ALPINE CITY COUNCIL MEETING AGENDA

NOTICE is hereby given that the CITY COUNCIL of Alpine City, Utah will hold a meeting on **Tuesday, March 10, 2015 at 7:00 pm** at Alpine City Hall, 20 North Main, Alpine, Utah as follows:

- B. **Eagle Point PRD Preliminary Plan Exceptions Review – Mark Wells and Taylor Smith – Approximately 800 W 600 N:** The City Council will make determinations on requested exceptions for the Eagle Point PRD for the final plan.

SUBJECT: Eagle Pointe PRD Preliminary Site Plan

Existi
betwe

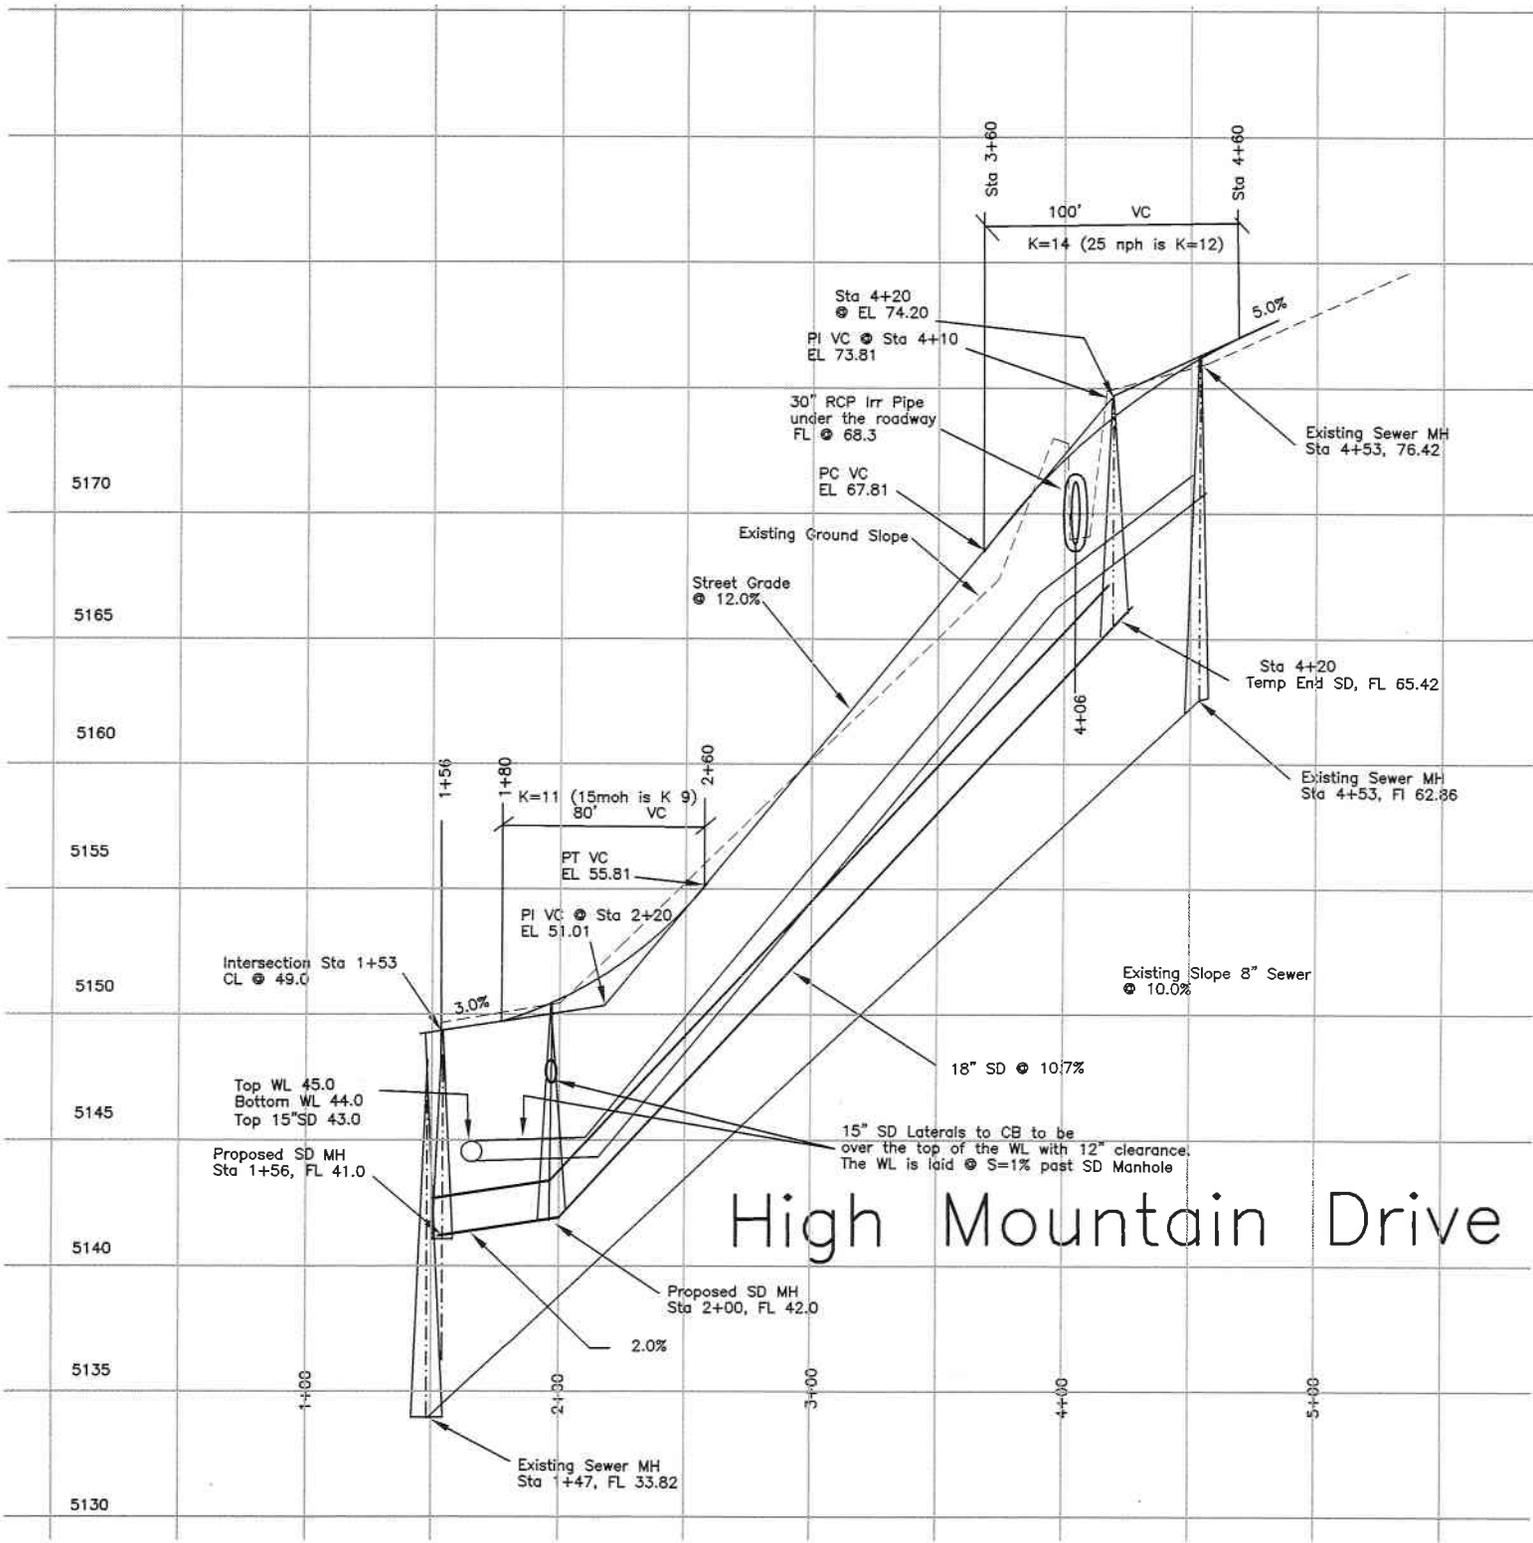
The proposed development shows extending Country Manor Lane to provide the required frontage for the lots. This phase extends and completes the northern end of Country Manor Lane by connection to Alpine Boulevard. A stub street is provided for future development of lots to the east named High Mountain Drive. Plan and profiles have been submitted for the streets and are approved. Curb, gutter and sidewalk are shown to be constructed and extended from where the current road ends through to Alpine Boulevard on both sides of the road.

There is an existing 8-inch sewer line in Country Manor Lane that will be extended to serve the additional lots. Sewer has also been stubbed eastward for future development. A 4-inch lateral will be required for each lot and is shown on the plans.

The plans show storm water being collected via catch basins and transported south via a piped system. A detention basin was appropriately sized and built to handle the capacity in an earlier phase of Bennett Farms. The drainage from this phase of development drains to this basin. The storm drain will be stubbed to the end of High Mountain Drive for future development.

GRADING & DRAINAGE PLAN

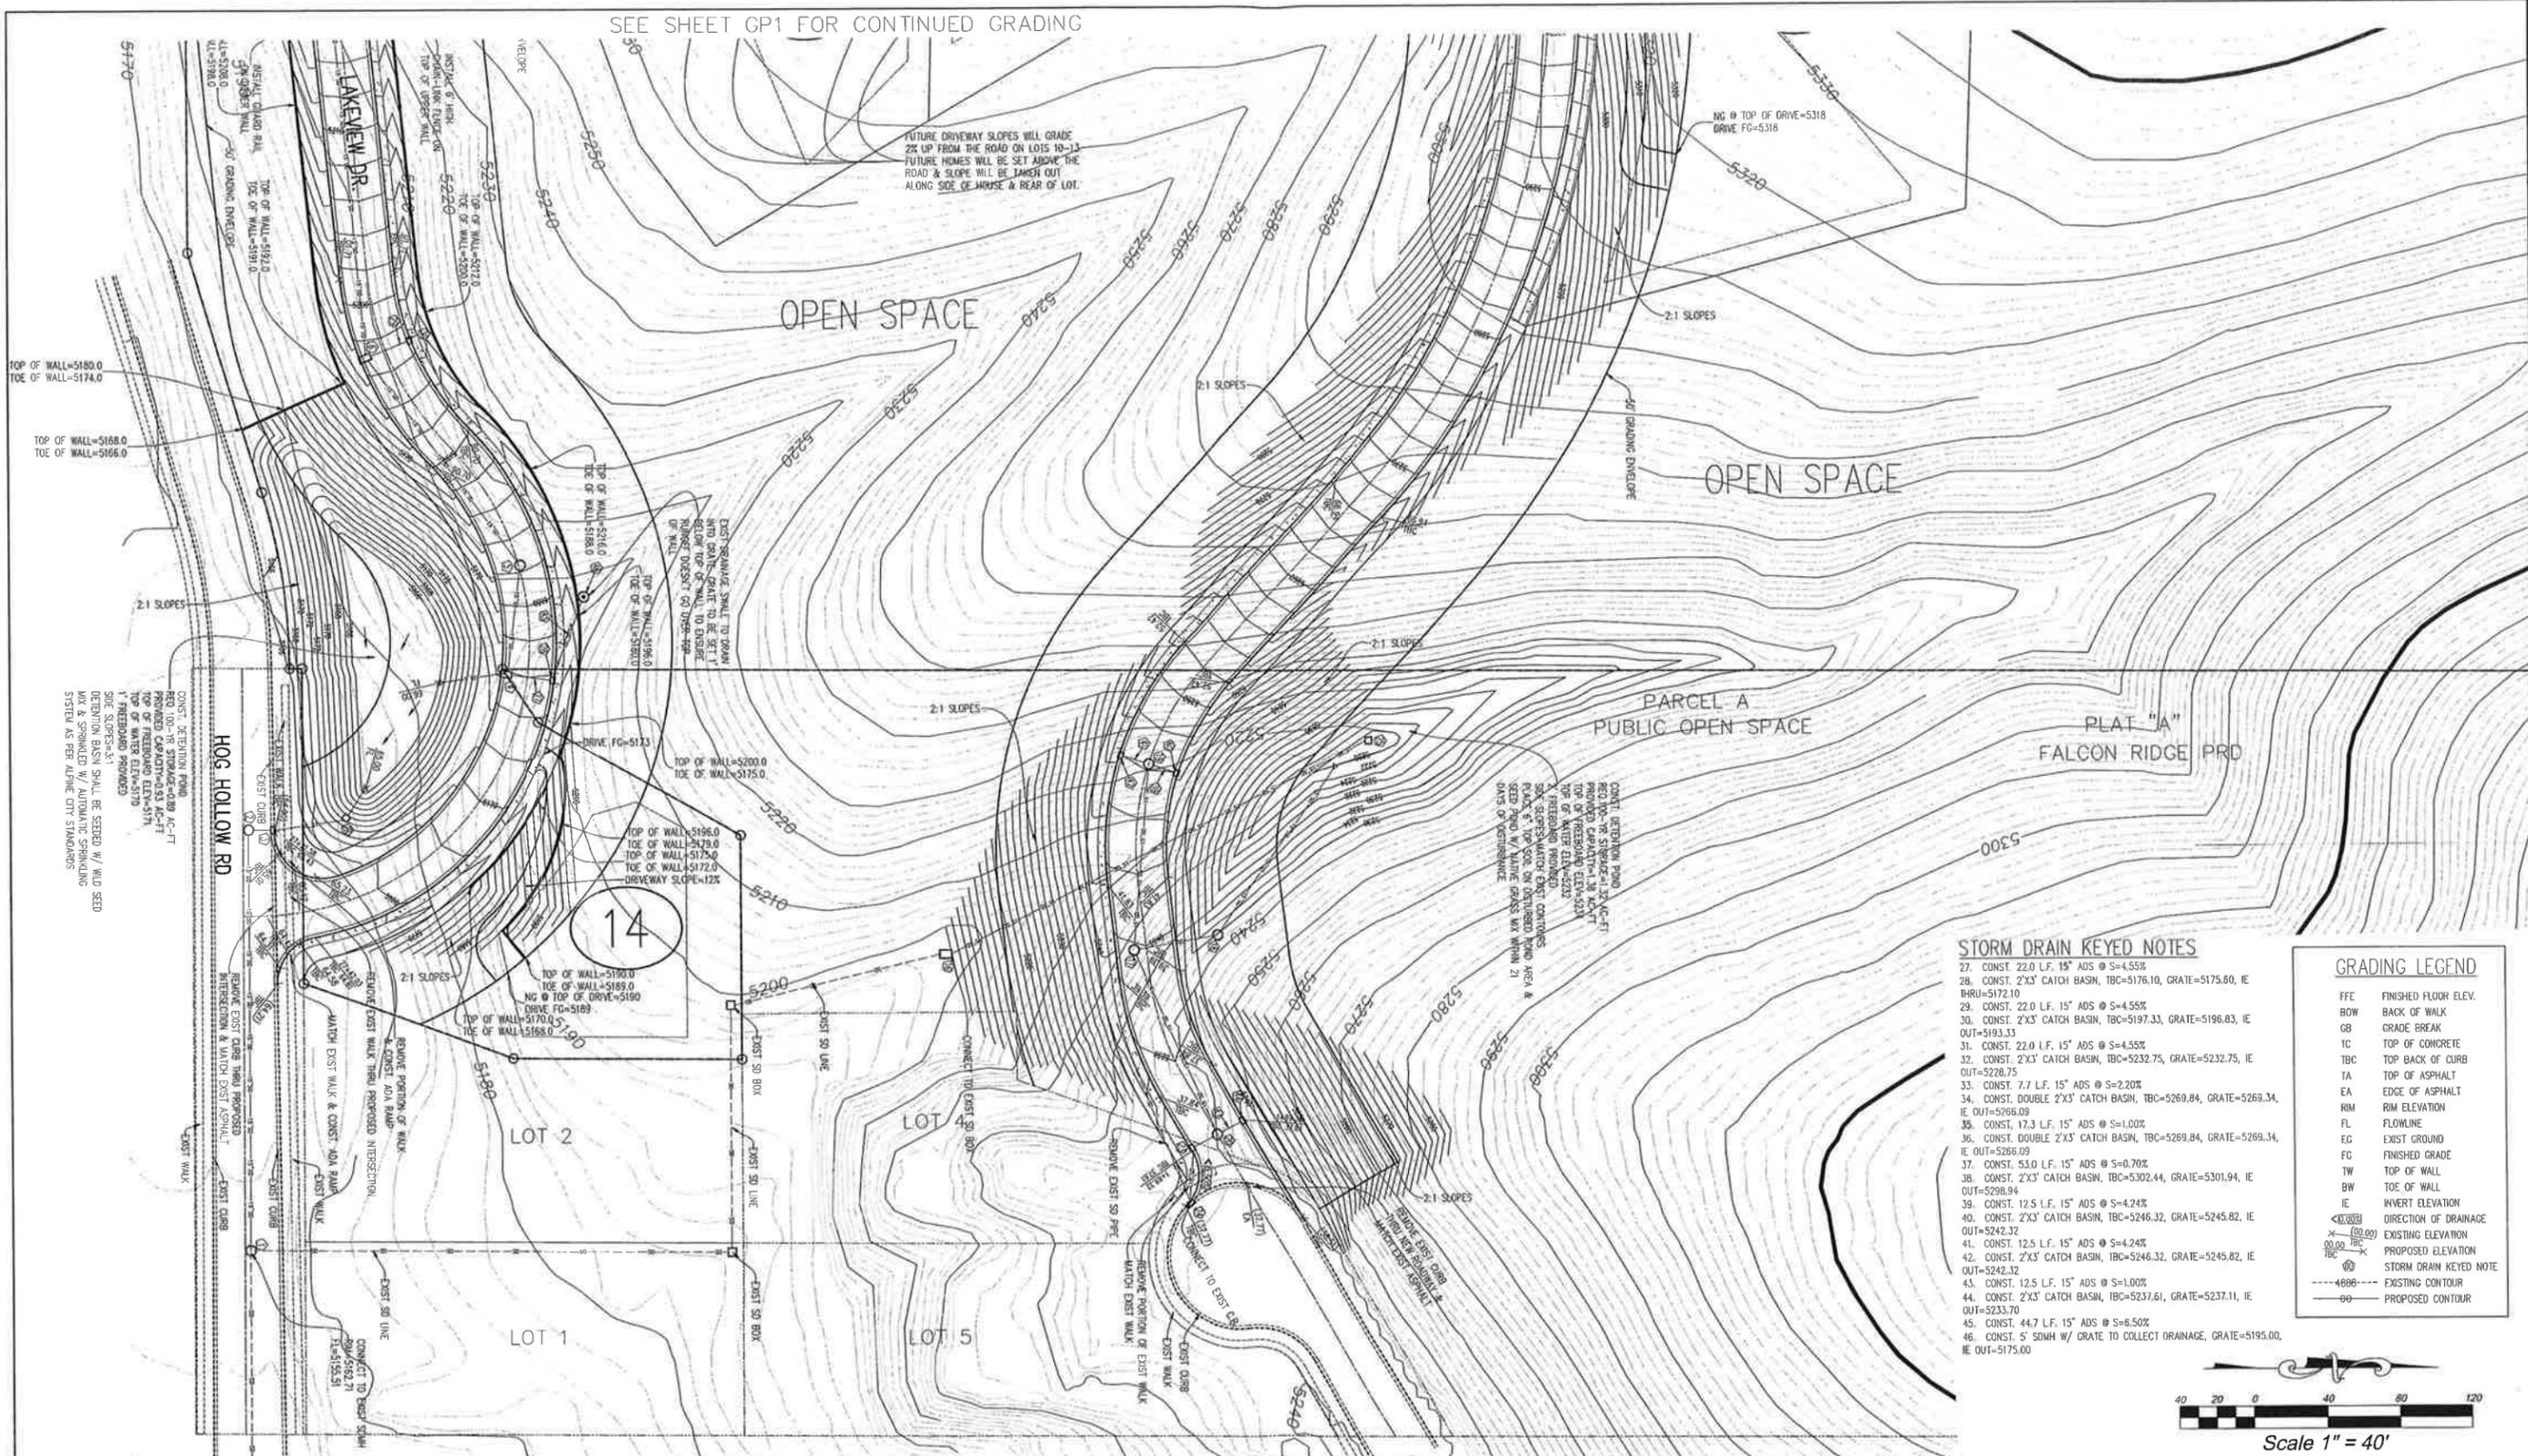
The proposed plans show an approximate line where fill material would extend beyond the 50-foot clear zone as identified in the Cut/Fill Ordinance (Section 4.17). The original plan showed three minor retaining walls at the extension of Lakeview Drive so as to not require an exception to the ordinance regarding cut/fill slopes. The Engineering department directed the Developer to eliminate these minor walls and request an exception for the 50-foot clear zone in this area. We are in support of an exception at this location as it is not wise to have a small retaining wall at the end of a long fill/cut slope, when the better design is to simply run the cut/fill slope another 10-20 feet to existing ground. **An exception to the 50-foot clear zone (4.17) to eliminate three minor retaining walls will require a recommendation by the City Engineer, Planning Commission, and approval by the City Council as outlined in section 4.1.2 of the Development Code.**

The plans are showing 2:1 cut/fill slopes on all slopes, which do not meet the Cut/Fill Ordinance as found in section 4.17. A letter from Eartheq Engineering was submitted which ensures that the existing geotechnical report is still valid for the development. That report specifies the methods, material, and erosion control standards used to build 2:1 slopes. The City Engineer accepts and recommends the methods described in the report. **An exception to the Cut/Fill Ordinance to allow 2:1 cut/fill slopes to be used within the development will require a recommendation by the City Engineer, Planning Commission, and approval by the City Council as outlined in section 4.1.2 of the Development Code.**

- **approval for the use of retaining walls (Section 3.9.7.4)**
 - **approval in change of use: 931 square feet of current public open space being changed to public right of way in exchange for 7,280 square of public open space.**
